**CITY OF NAPOLEON
BUILDING CONSTRUCTION PERMIT
(1, 2 or 3 Family Dwelling)**

Zoning "1A" Intended use of Building: Converting existing detached garage flat roof to 6/12 slope gable roof.

REMODELING FLAT ROOF TO GABLE ROOF

Remodeling flat roof to gable roof

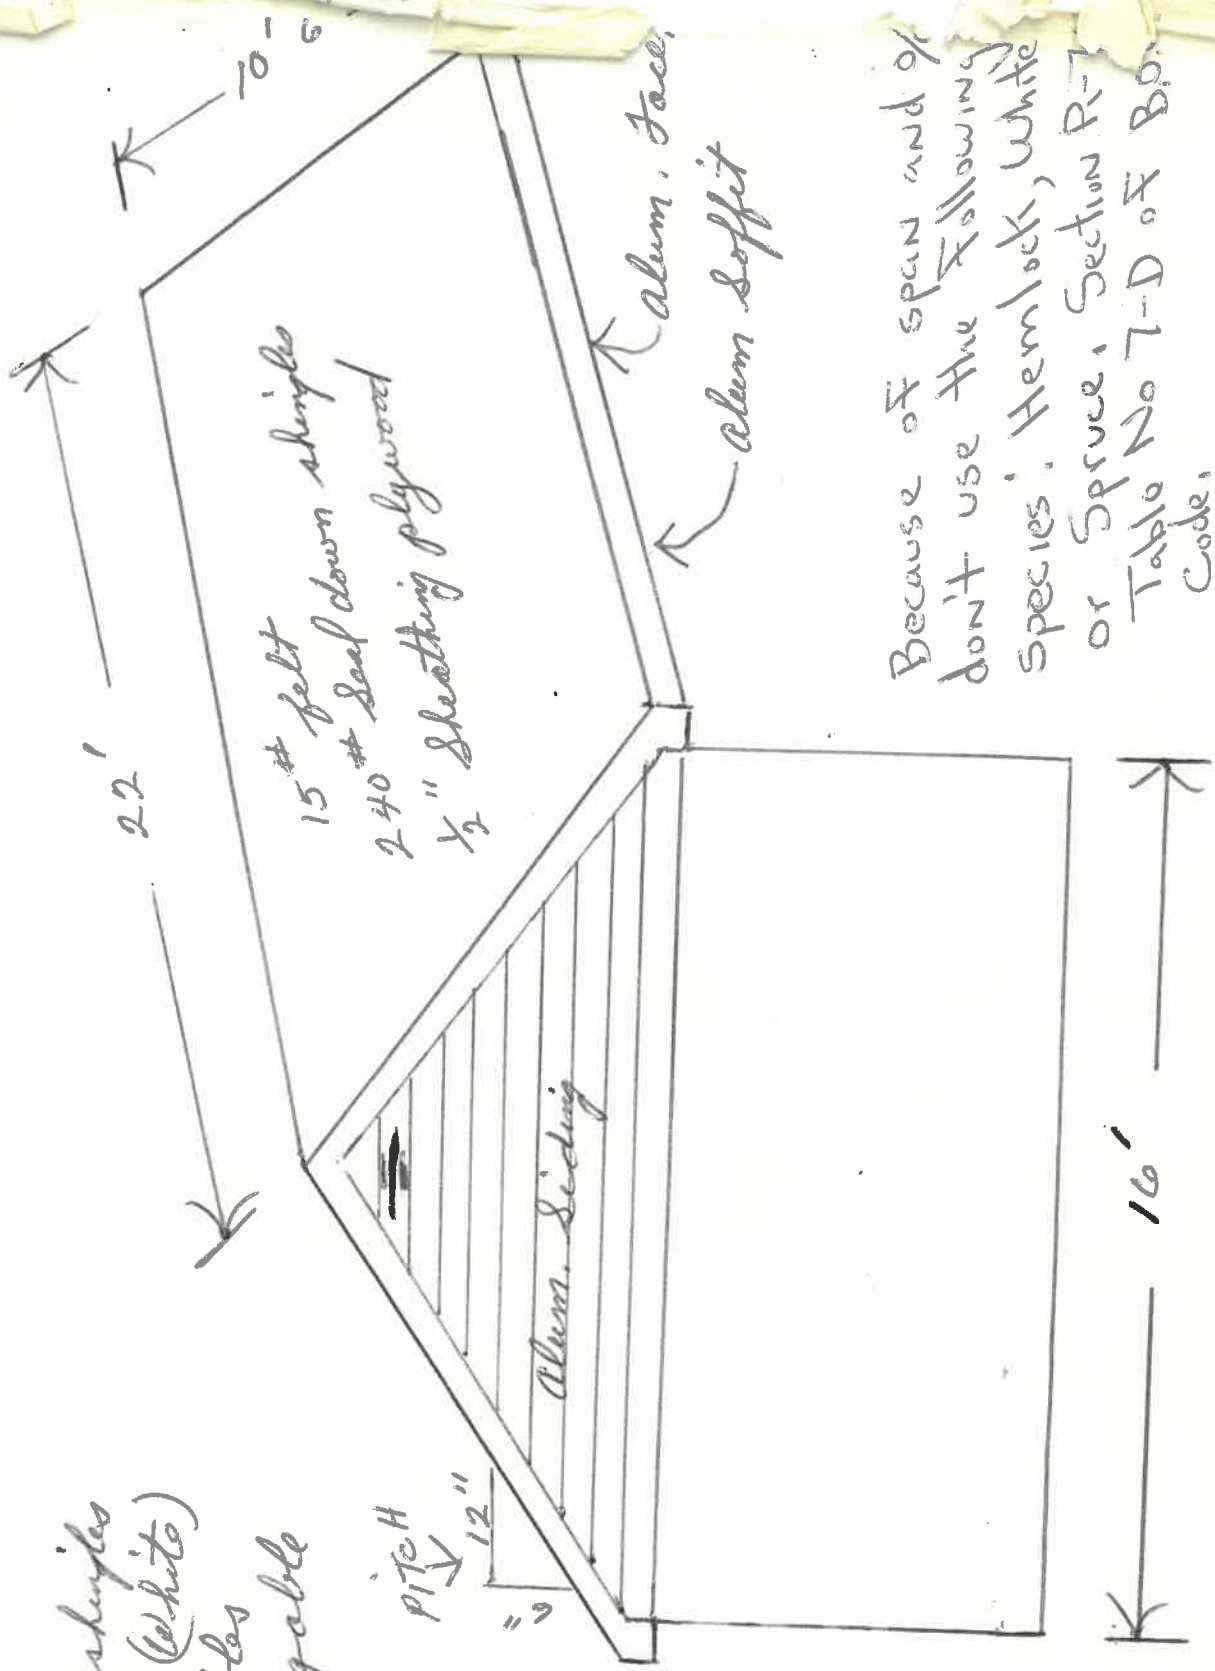
Because of span and of
 don't use the following
 species: Hemlock, White
 or Spruce. Section R-7
 Table No 7-D of B.C.
 Code.
